CENTERVILLE CITY PLANNING COMMISSION AGENDA

NOTICE IS HEREBY GIVEN THAT THE CENTERVILLE CITY PLANNING COMMISSION WILL HOLD ITS REGULAR PUBLIC MEETING AT 7:00 PM ON JULY 25, 2018 AT THE CENTERVILLE CITY COMMUNITY CENTER AND CITY HALL COUNCIL CHAMBERS, 250 NORTH MAIN STREET, CENTERVILLE, UTAH. THE AGENDA IS SHOWN BELOW.

| 7:10 | 1. Public Hearing - Conditional Use Permit for Accessory Building at 1771 N 125 East

5. Public Hearing - Conceptual Site Plan - South Davis Metro Fire Station - 300 South Main Street

SITE PLAN

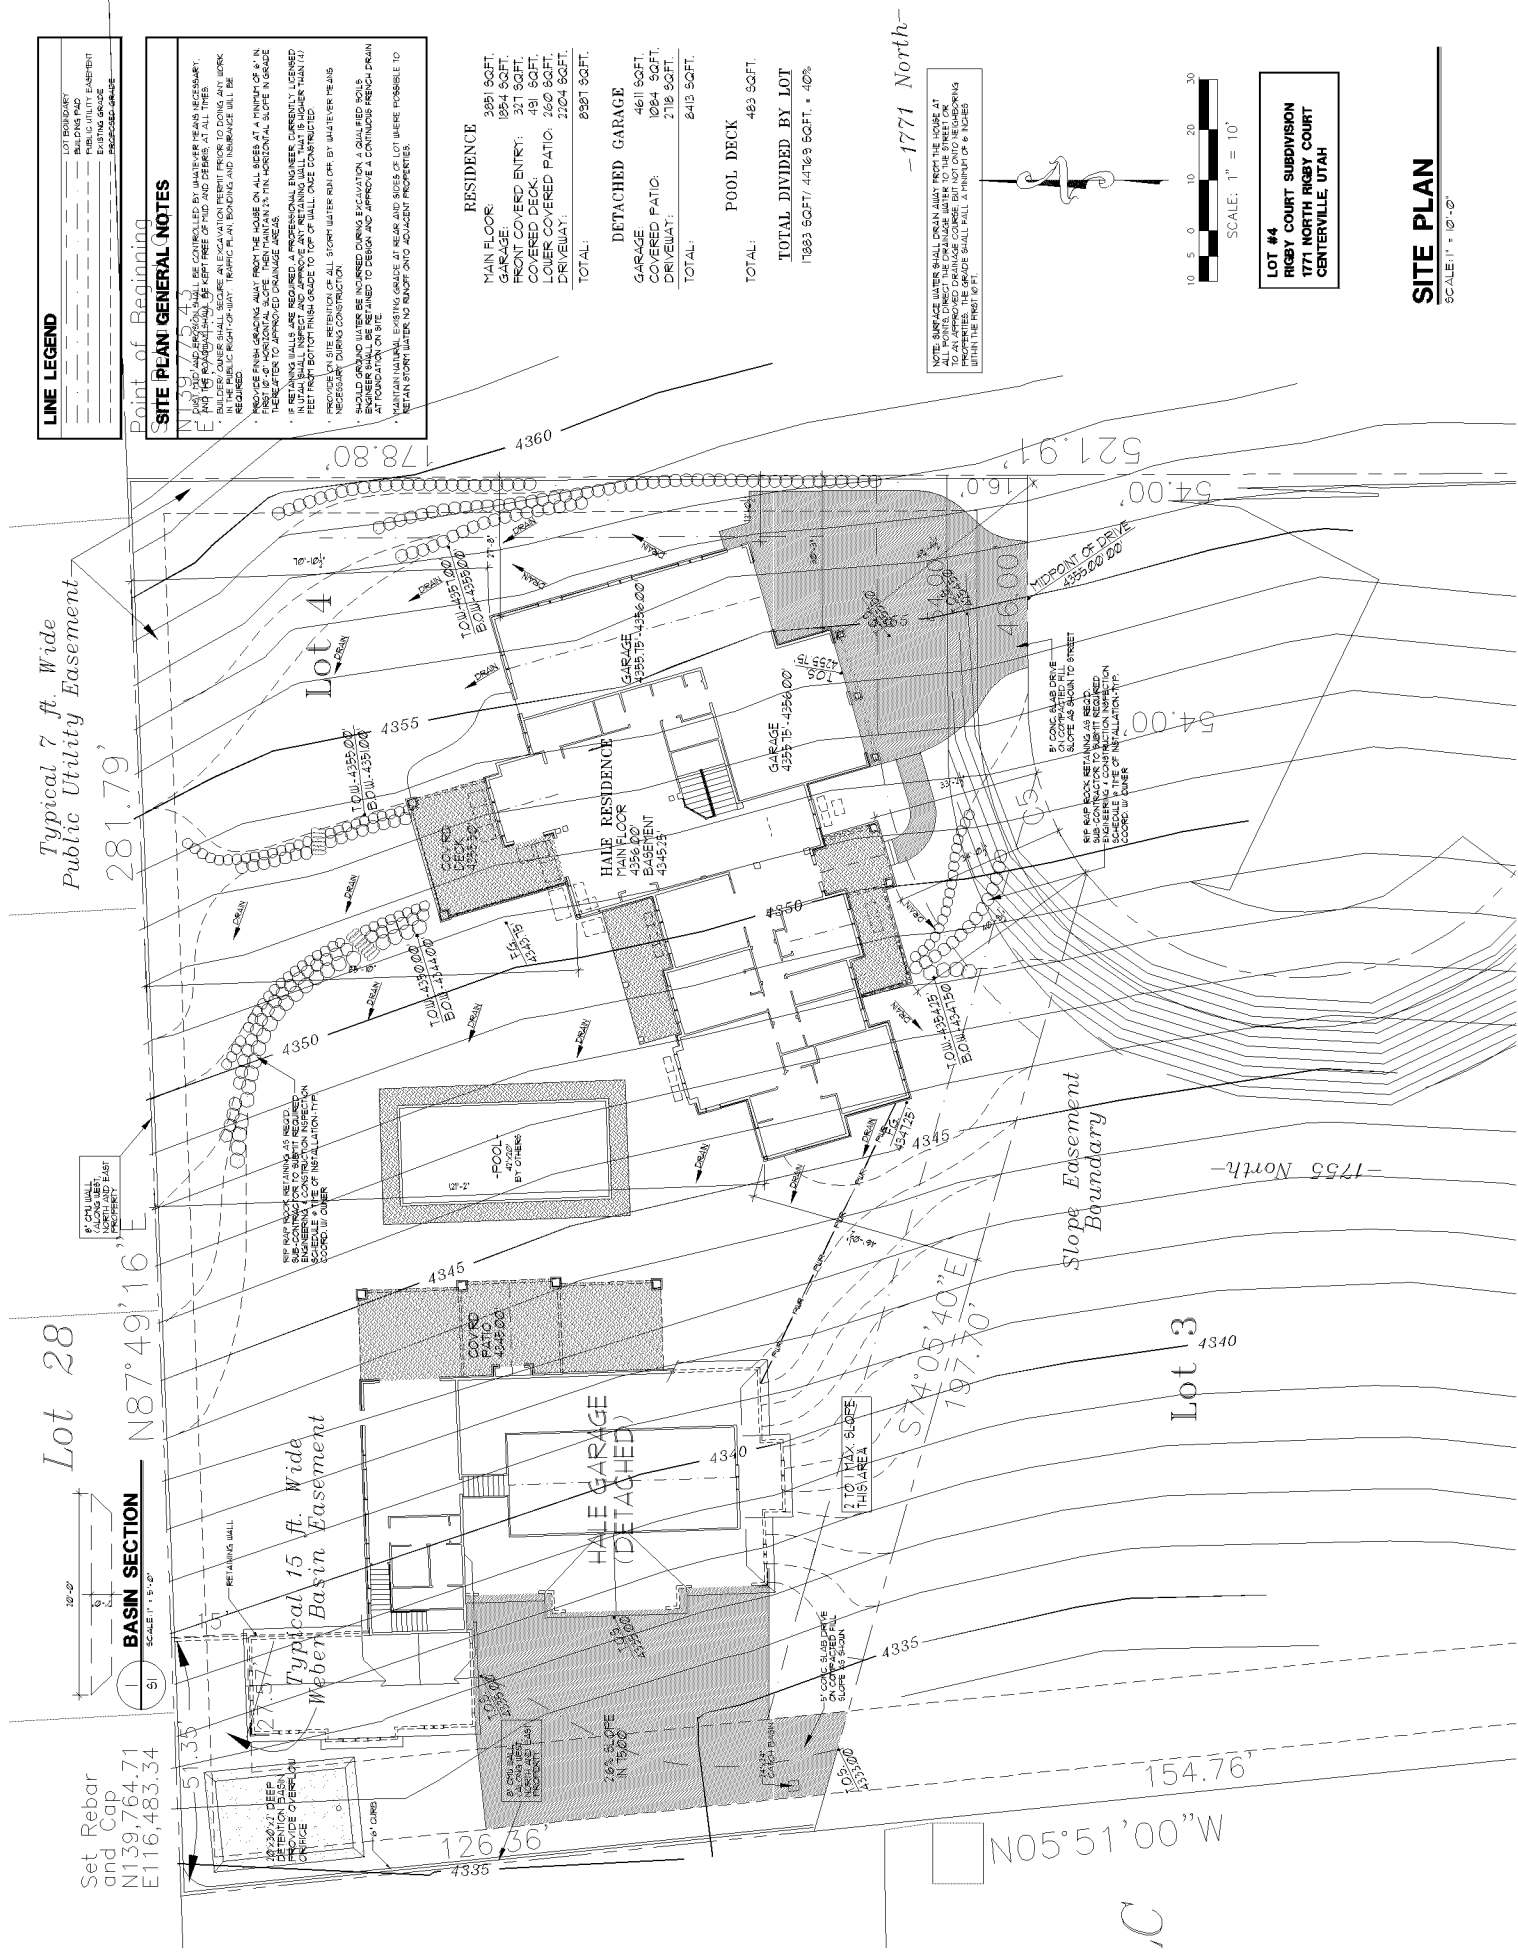
- ❖ As calculated by the architect on the site plan, the combined impervious surface including the main dwelling, detached garage, covered patios, pool deck, and driveways comes to 17,883 square feet. $17,886 / 44,866 = 39.8\%$

1. This Conditional Use Permit is for the accessory building detached garage at 1771 N 125 East, for an increase in height up to 23' average height.
2. The garage is approved as the architectural elevations and site plan submitted in July 2018.
3. The detached garage shall not be used as an accessory dwelling unit or guest house.
4. The development of the property must comply with the Hillside Impervious surface standards, as outlined in 12.42.
5. The applicant will need to receive a Building Permit for this structure from Centerville City.

Figure 3 Installed driveway with over 20% slope

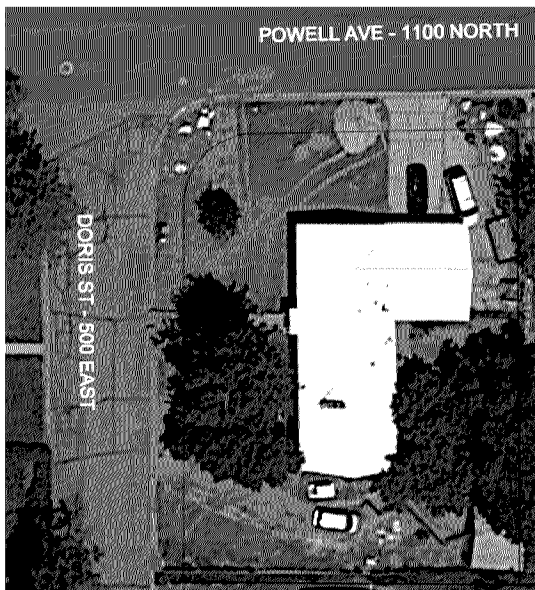
There are two driveways on this lot: one entering from Powell Ave, and a recently added driveway entering from Doris Street. The driveway access from Doris Street is not a City approved access and was paved without a permit from the Public Works Department. According to the Public Works Director, Randy Randall, the driveway was not built to city standard and code requirements. The driveway has a slope over 20%, where our code only allows 12%. The city also would have required that the owner put in a sidewalk as per our city standard at this time at the building of the driveway. The Public Works director is concerned about the slope of the driveway for the size and weight of the trailer, and has requested that the applicant not use this driveway to store the trailer, due to the damage it would cause our City Road entering and exiting the driveway.

The applicant can either eliminate the curb cut on Doris Street, and remove the driveway from the Public Right of Way, or fix the driveway with City Approval according to our City Standards and Specifications.

OAKRIDGE ASSISTED LIVING
CONCEPTUAL SITE PLAN

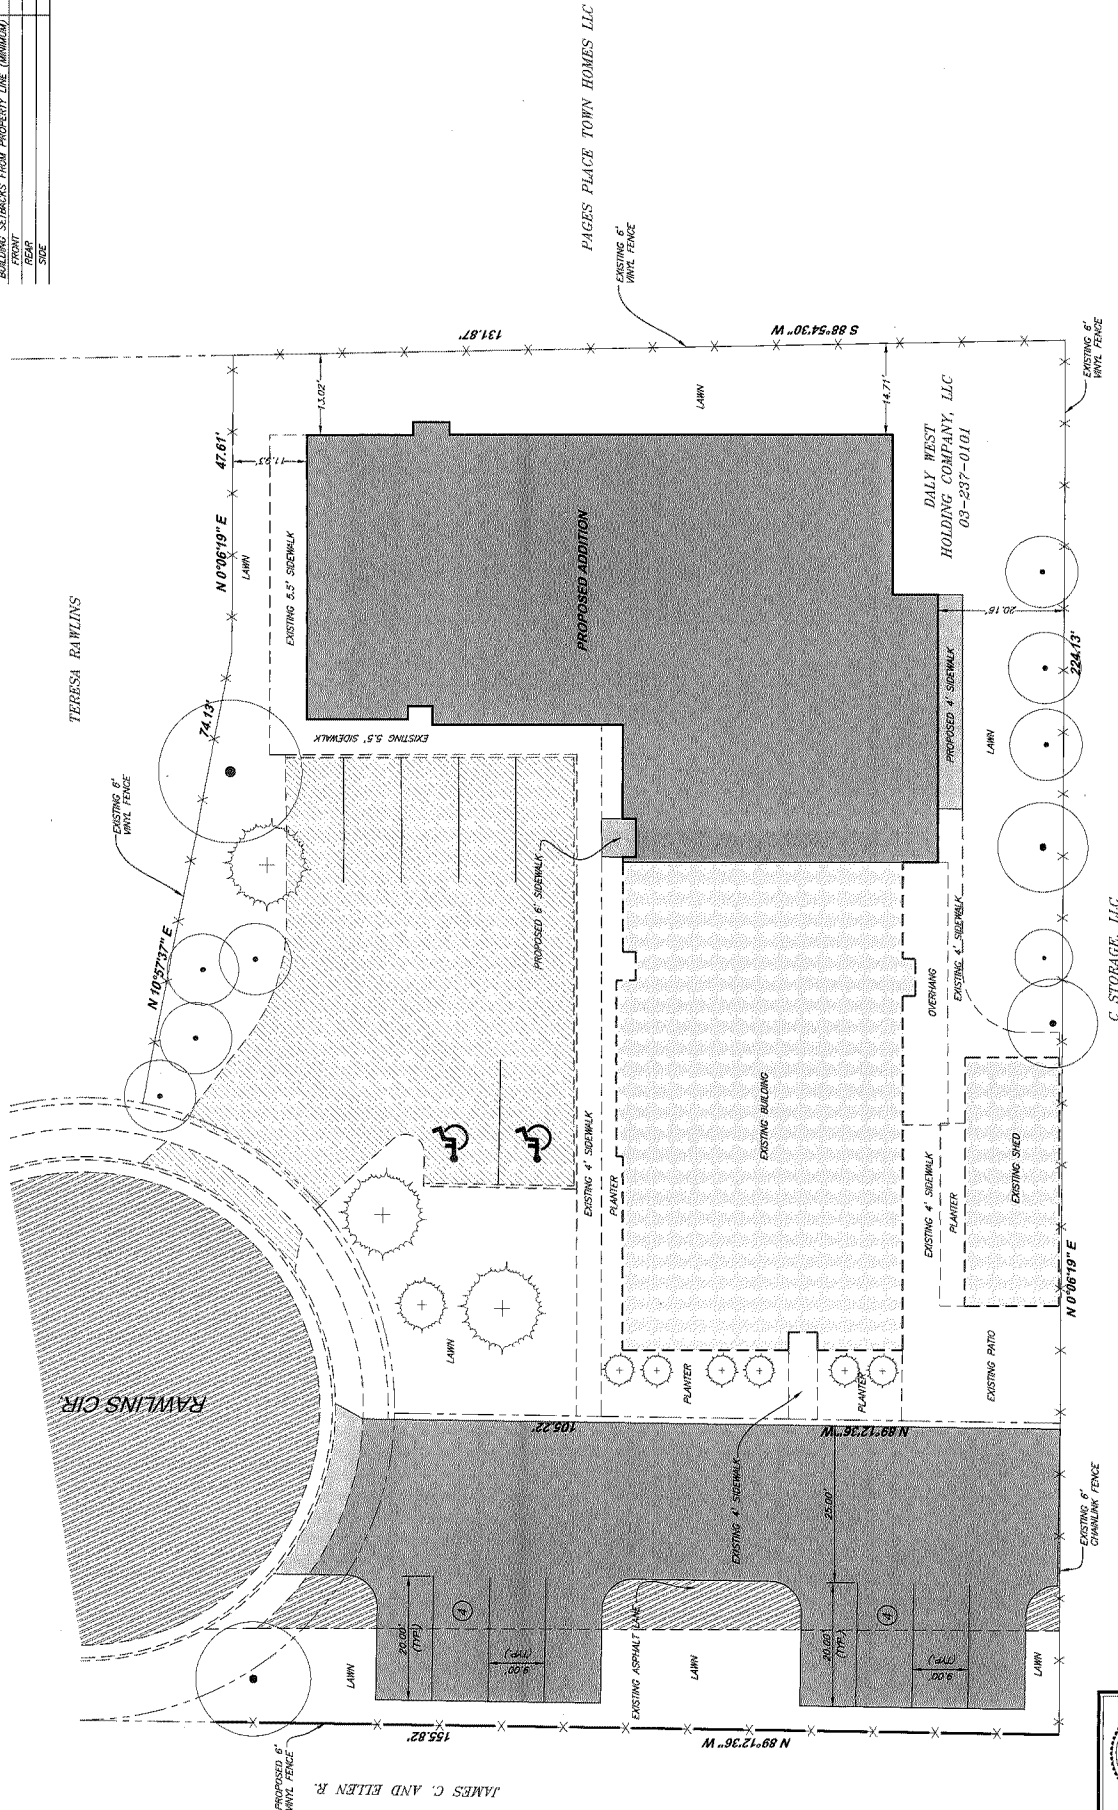
required 40% landscaping calculation of the site, a written request will need to be provided. The site certainly has constraints for what the applicant desires the new building to be, along with sheds, patios, and parking lots. The applicant has more parking than is required – presumably for the guests and family members of the residents, and two wide driveways. The number of parking stalls could potentially be reduced to slightly increase the percentage of landscaping. From a zoning perspective, the second parking lot to be added on the new lot is not necessary according to zoning parking calculations. The only required number of parking stall for this site is 5, based on the number of beds and employees. The applicant could consider minimizing or reducing the number of stalls installed on the second parking lot for guests and create a more visually appealing landscaped area in order to increase their landscaping percentage.

Currently, a 20' wide storm drain easement runs through the middle of the proposed second building. The applicant needs to remove and relocate the storm drain, vacating the current easement and creating a new 20' wide one to the north side of the property, as approved by the City Engineer.

3. As approved by the City Engineer, the applicant shall vacate the current storm drain easement running through the middle of the lot, and remove and relocate the storm drain, and create a new 20' easement on the north side of the property (the south side of newly acquired Parcel A), adjacent and parallel to the 7' PUE on the north property line of the original lot) in order to line up with the Culinary Waterline.

4. The applicant shall receive approval of Site Plan from Davis County Fire Marshall
5. The applicant shall submit a final landscaping plan that complies with the landscaping standards for multi-family residential as outlined in 12.52 OR submit a proposed landscaping waiver of strict compliance for the Planning Commission to review at Final Site Plan.

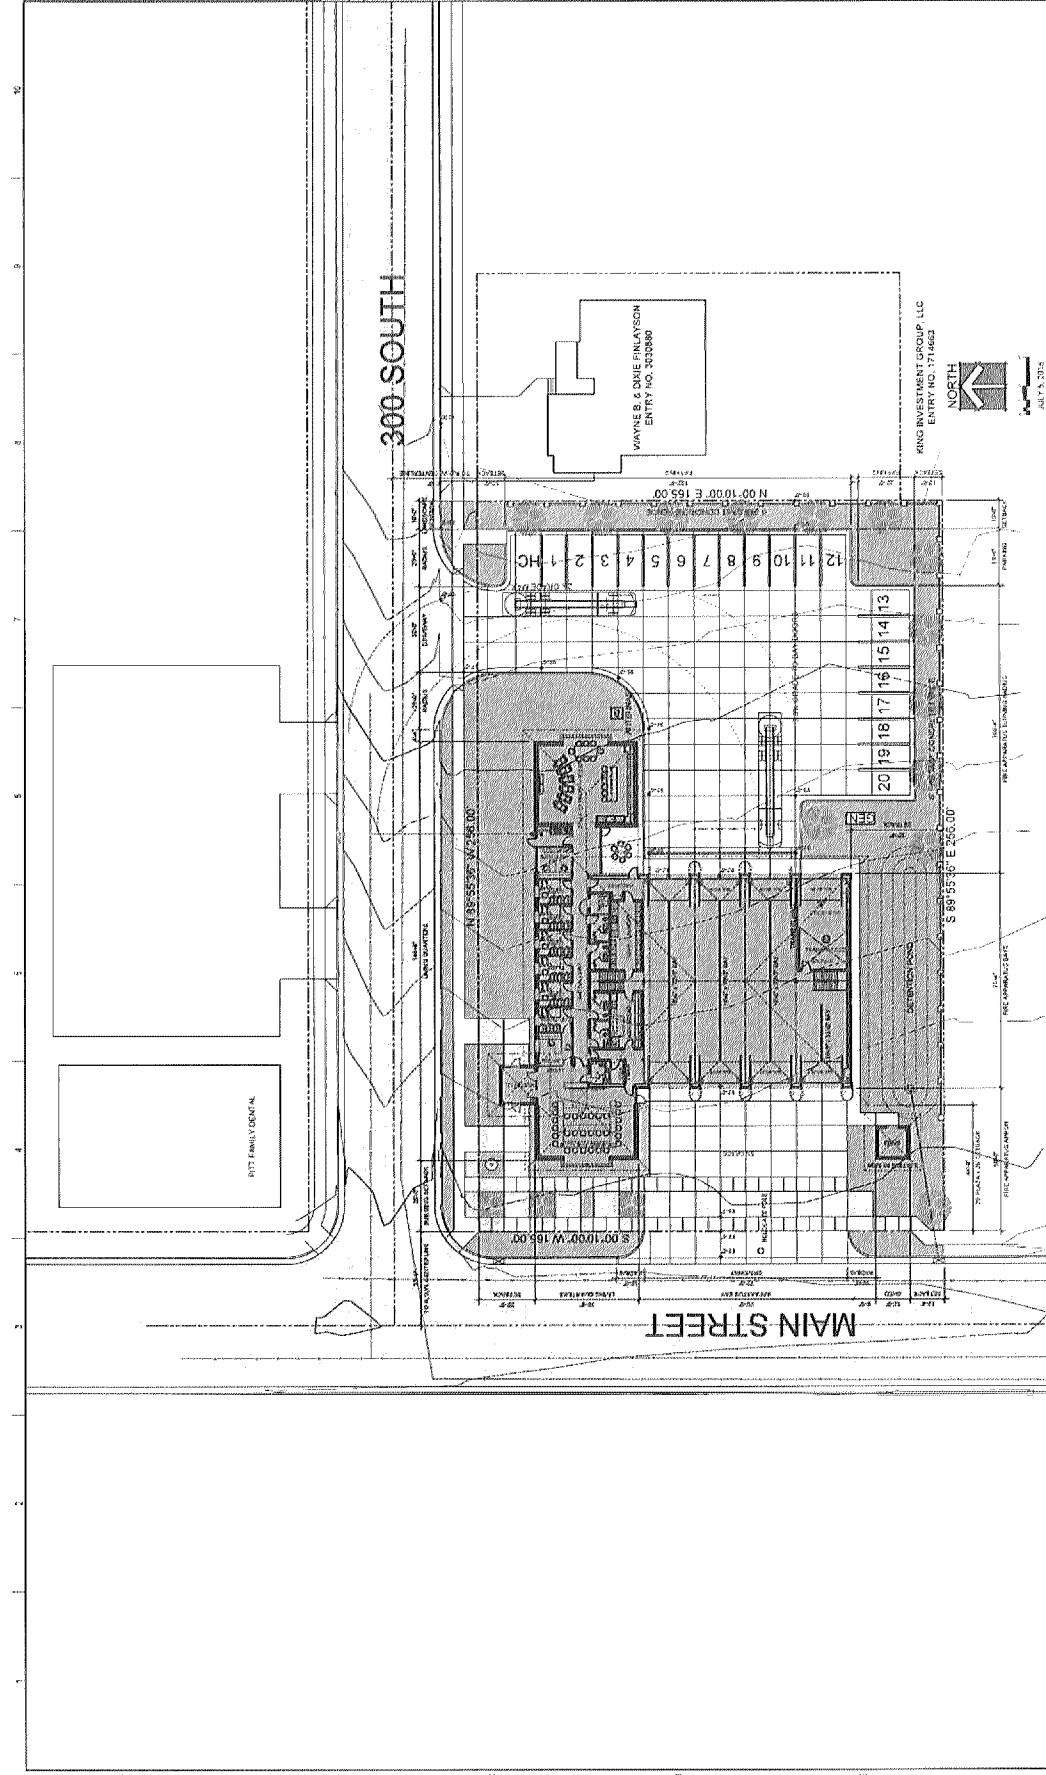
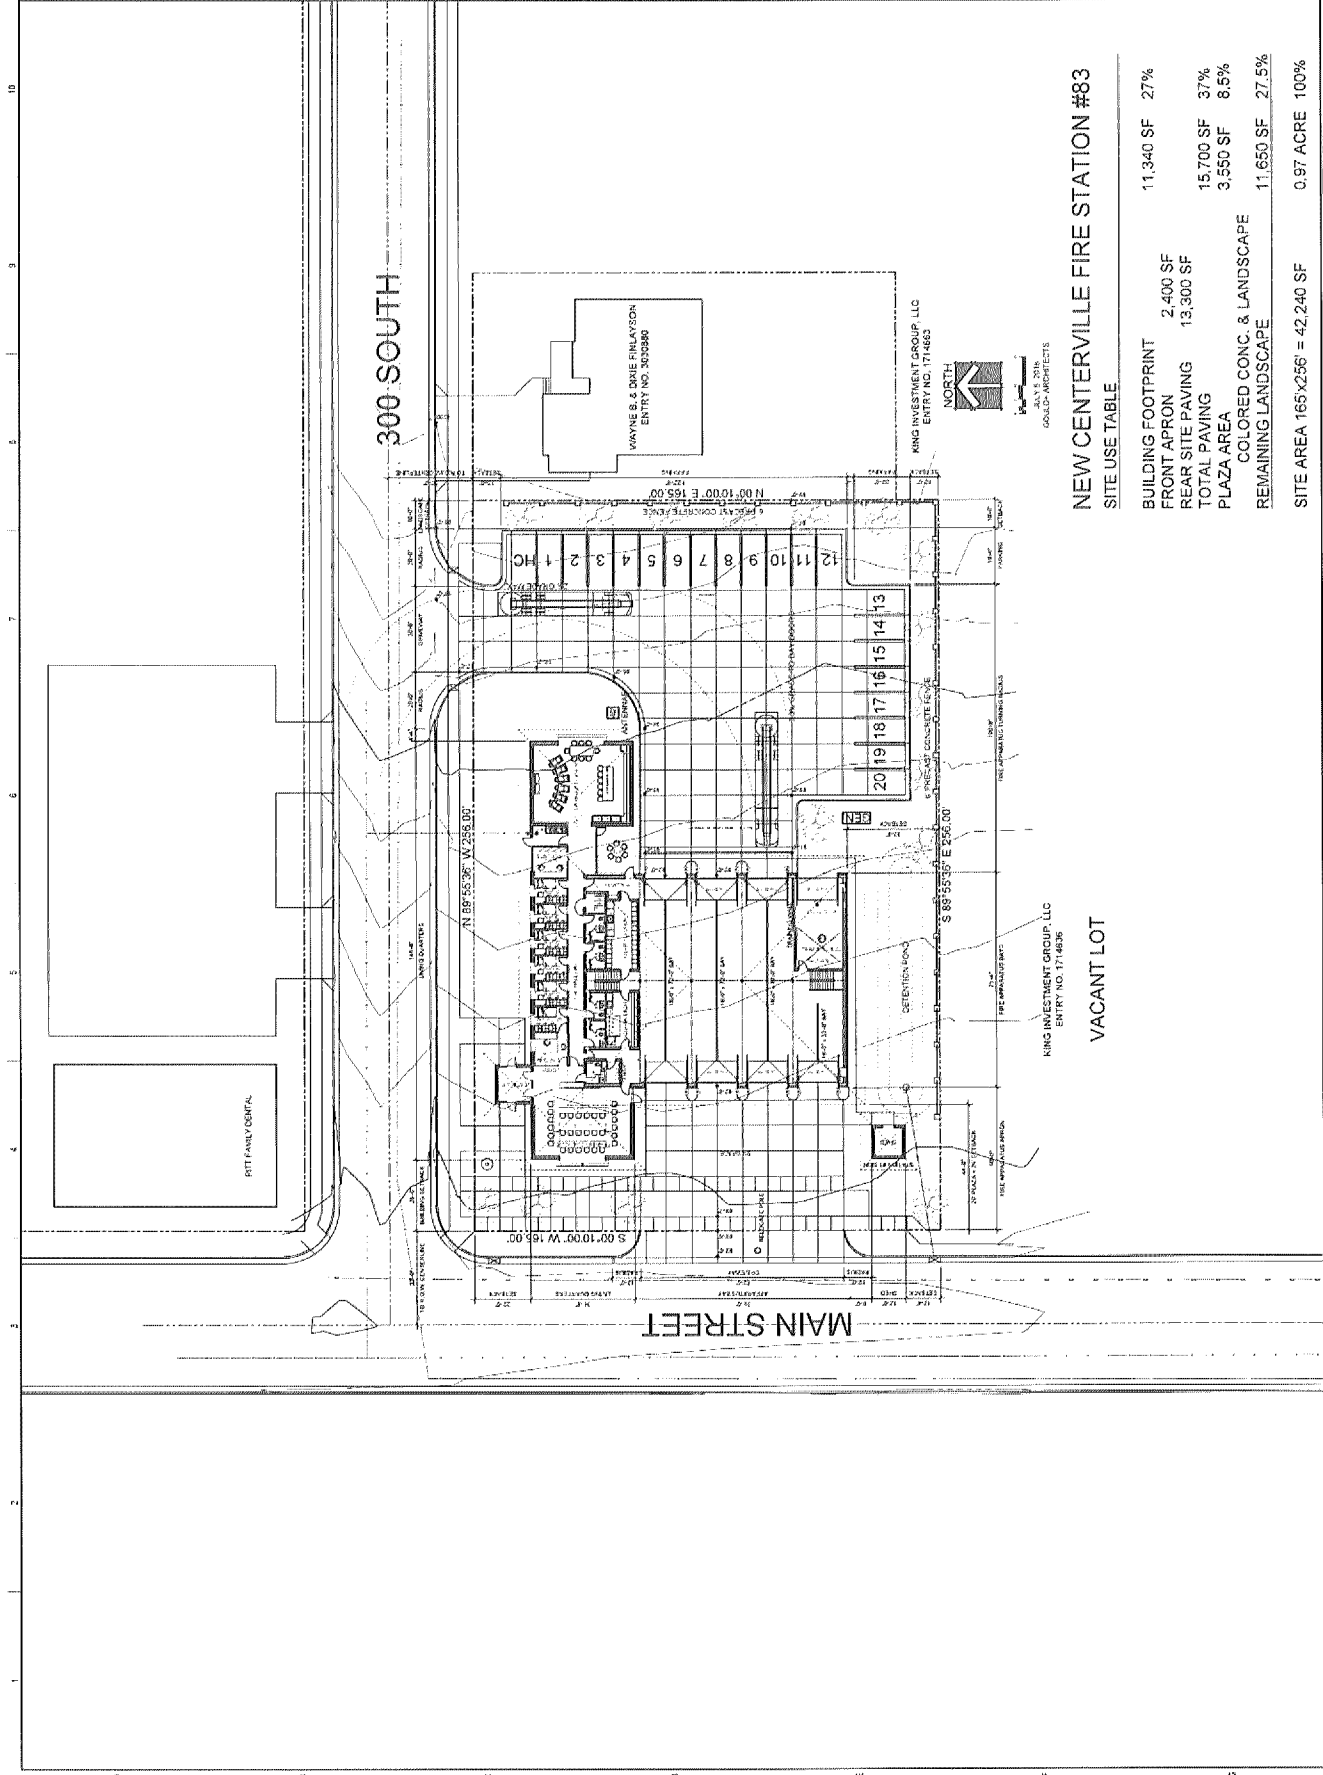
- ***Building Entrances*** – *In reviewing the site plan, the building does NOT provide the expected “RETAIL” use building and is oriented to a Civic Use. Additionally, it provides “at least one entry door,” however the “at-grade” expectation is NOT provided.*

- ***Sidewalk Requirements*** – *The proposed design of “checker-board” pattern along the apparatus bay leading through the landscaping north of the bay does provide the expected enhancement of the “pedestrian experience.”*

maintain or improve the pedestrian use and safety. By doing so, it improves the activity levels and use of the streetscape area and create a pedestrian-friendly environment. In reviewing the concept site plan, the proposed layout expands the existing driveway approach apron potentially “negatively affects” the pedestrian experience.

- (a) Provide the missing a dimensional tabulation for the Civic Use Lot Type.*
 - (b) Comply with the entrance spacing requirement, or as amended*
 - (c) Comply with the RBL frontage width requirements, or as amended*

- (d) Address the south side 15-foot side yard spacing or provide a “unified gather area.”*
 - (e) Comply with the street-level floor elevation shall be no more than 12 inches above the fronting sidewalk elevation, or as amended*

- (h) Provide the required 34 parking stalls or seek a “specific user” parking modification.*
 - (i) Comply with the Civic Lot Type height limitation of 40’ from grade of Main Street, as shown in 12.48.350*
